M.I.T Apparels Ltd. (9687)

12.MAY.2014

Identified Priority 2 Concerns

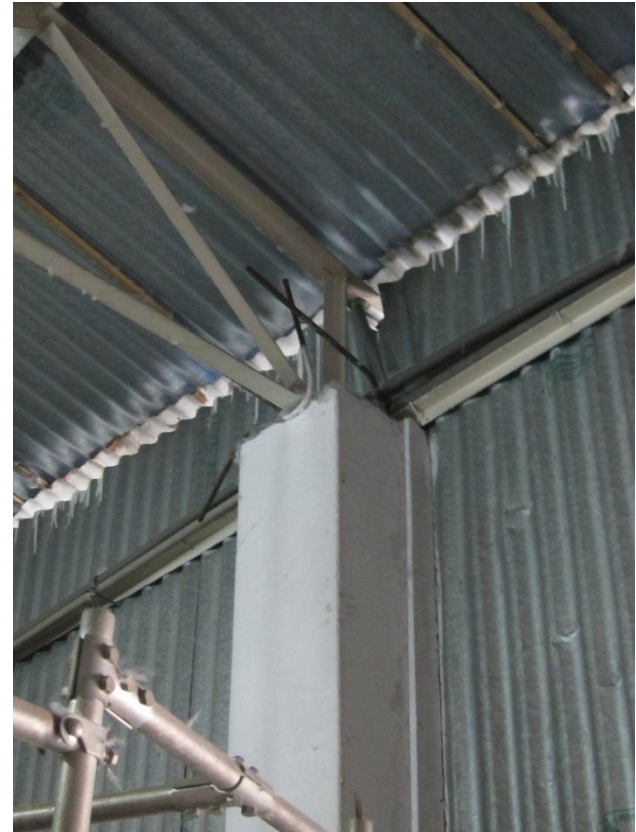
- No roof plan and details specified in the drawings

Steel roof truss and canopy have been built without any plan or details specified on the drawings.

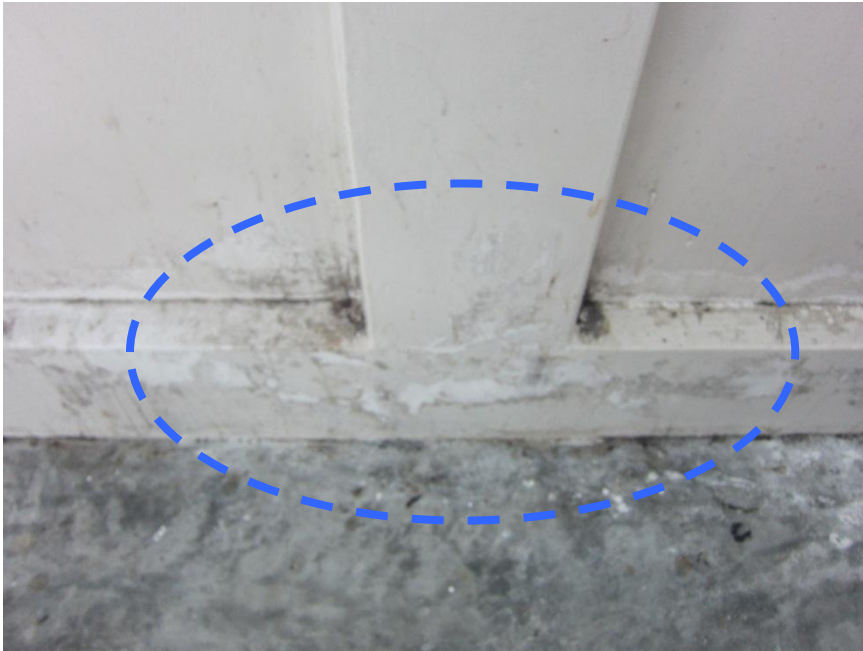
Steel reinforcement are left exposed on the top of reinforced concrete column. It is unclear whether rust-proof paint is applied.
